# CONVAIR

## COMMERCIAL CHANGE PROPOSAL

SPEC NO.: ZD- 22-003

MODEL: 22-2 (Convair "880")

FIGURE 3.19-2

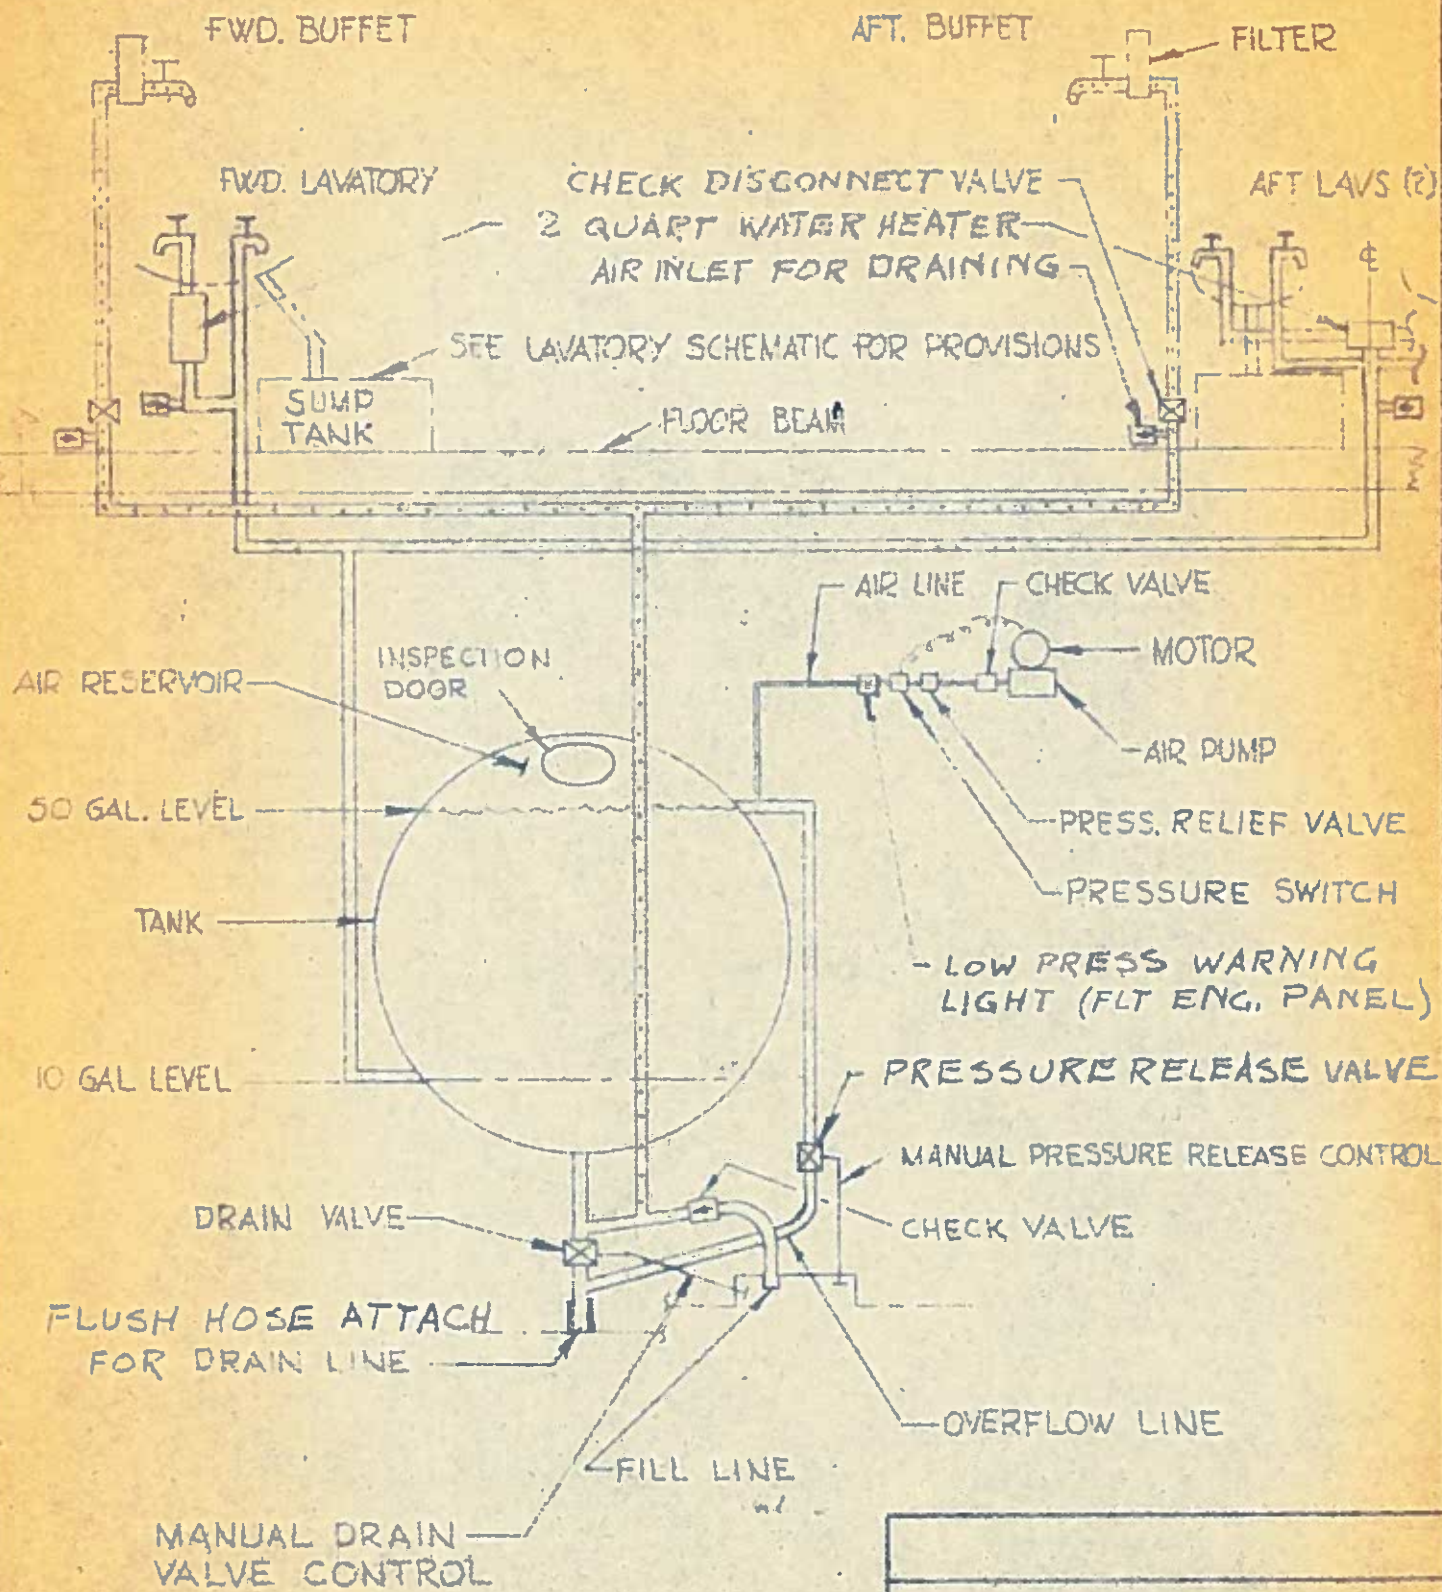
Page 115B, FIGURE 3.19-2 WATER SYSTEM:

Enclosure: (A) One copy Figure 3.19-2 WATER SYSTEM SCHEMATIC (for information only)
